APPLICATION NO.	FILING DATE	FIRST NAMED INVENTOR	ATTORNEY DOCKET NO.	CONFIRMATION NO.
10/784,841	02/23/2004	Bruce Allan Crawford	BC-04	1477
7590 05/22/2006			EXAMINER	
James Addison Barry, Jr. 105 Glenway Point			MEISLIN, DEBRA S	
Lebanon, TN 37087			ART UNIT	PAPER NUMBER
			3723	
			DATE MAILED: 05/22/2006

Application No.	Applicant(s)				
	10/784,841	CRAWFORD, BRUCE ALLAN				
Office Action Summary	Examiner	Art Unit				
	Debra S. Meislin	3723				
The MAILING DATE of this communication appears on the cover sheet with the correspondence address Period for Reply						
A SHORTENED STATUTORY PERIOD FOR REPLY IS SET TO EXPIRE 3 MONTH(S) OR THIRTY (30) DAYS, WHICHEVER IS LONGER, FROM THE MAILING DATE OF THIS COMMUNICATION. - Extensions of time may be available under the provisions of 37 CFR 1.136(a). In no event, however, may a reply be timely filed after SIX (6) MONTHS from the mailing date of this communication. - If NO period for reply is specified above, the maximum statutory period will apply and will expire SIX (6) MONTHS from the mailing date of this communication. - Failure to reply within the set or extended period for reply will, by statute, cause the application to become ABAN

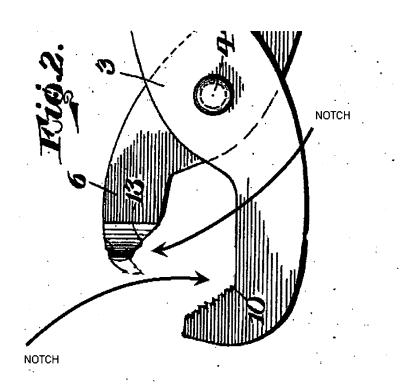
5. Claims 10 and 24-28 are rejected under 35 U.S.C. 102(b) as being clearly anticipated by Nation (1,782,364).

Nation discloses the claimed "notches" as shown below. The device of Nation is also capable of engaging a locknut.

Nation discloses the claimed "notches" as shown above. A recitation of the intended use of the claimed invention must result in a structural difference between the
